S E R V I C E N O T E

8665A Synthesized Signal Generator

I/O Assembly Replacement requires modification to Reference Assembly

FIGURE 1

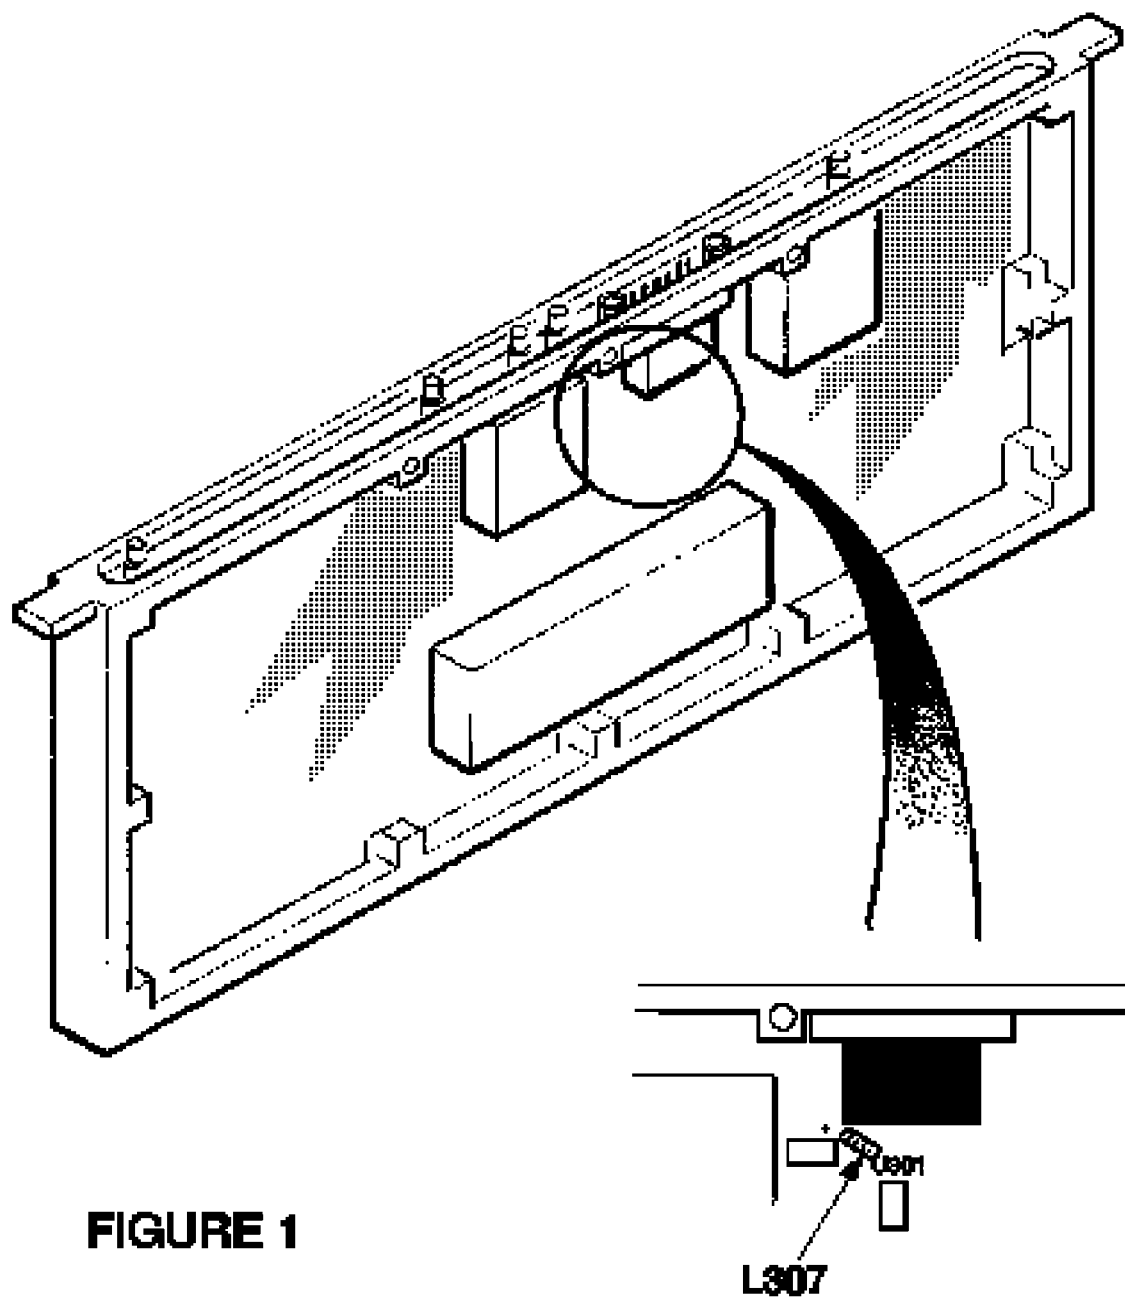
When an I/O assembly (08665-69104 or 08665-60204) is replaced in instruments (serial numbers noted above) a component on the Reference assembly (P/N 08665-61006) must be removed to insure proper operation of the reference oscillator.

Remove L307 on the Reference assembly. Refer to Figure 1 for component location. Re-calibration is not required.
